Technical Service Information

THM 3T40 (125C) NEW BELL HOUSING

Figure 1

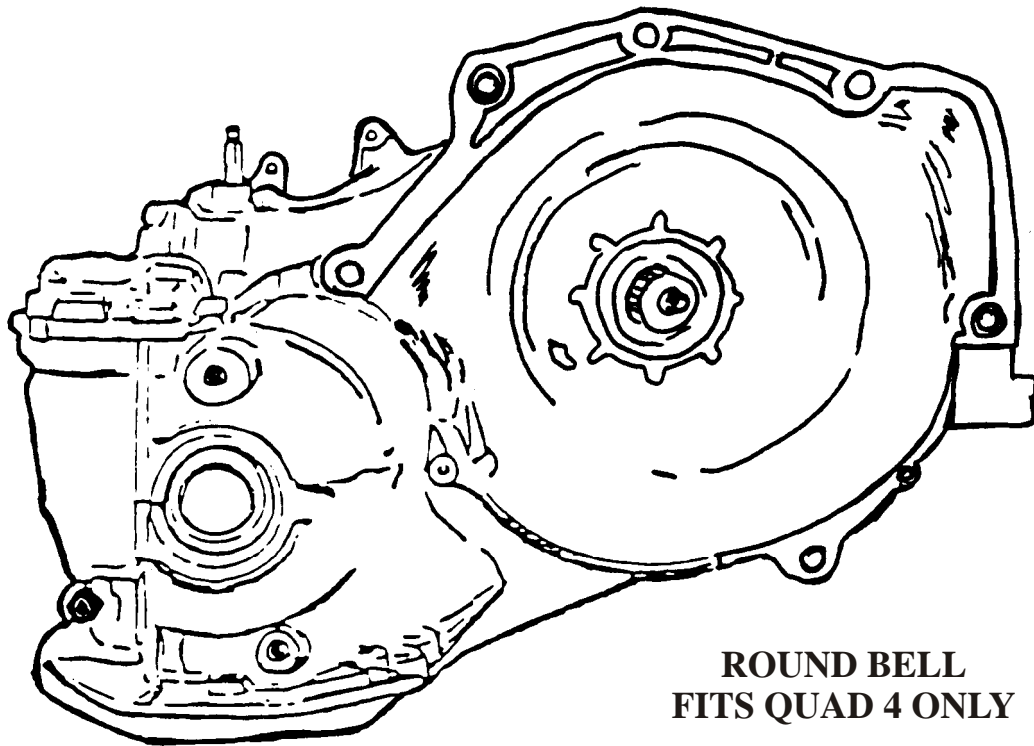
BEGINNING IN 1988 THERE WAS A NEW BELL HOUSING INTRODUCED THAT FITS ONLY THE NEW "QUAD FOUR" ENGINE. WE HAVE INCLUDED DRAWINGS FOR ALL OF THE 125 BELL HOUSINGS FOR COMPARISON. AS YOU CAN SEE THE "QUAD FOUR" BELL HOUSING IS UNIQUE AND WILL NOT INTERCHANGE.

**FLAT 125 BELL
FITS DOMESTIC ENGINES**

Figure 2

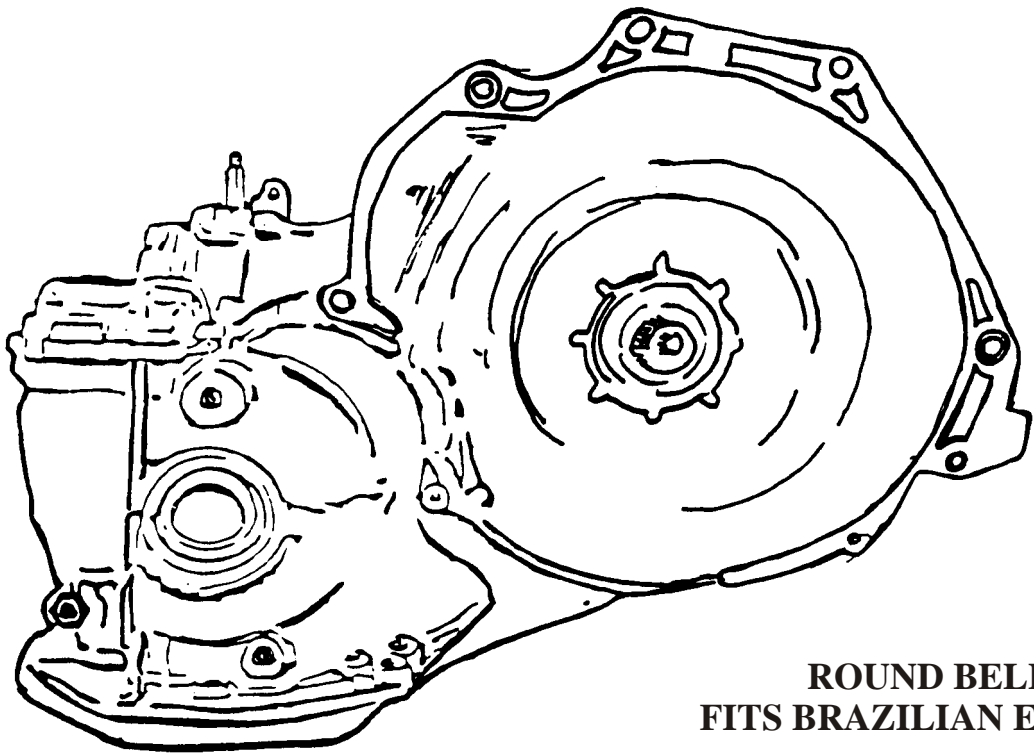
**ROUND BELL
FITS QUAD 4 ONLY**

**ROUND BELL
FITS BRAZILIAN ENGINE**
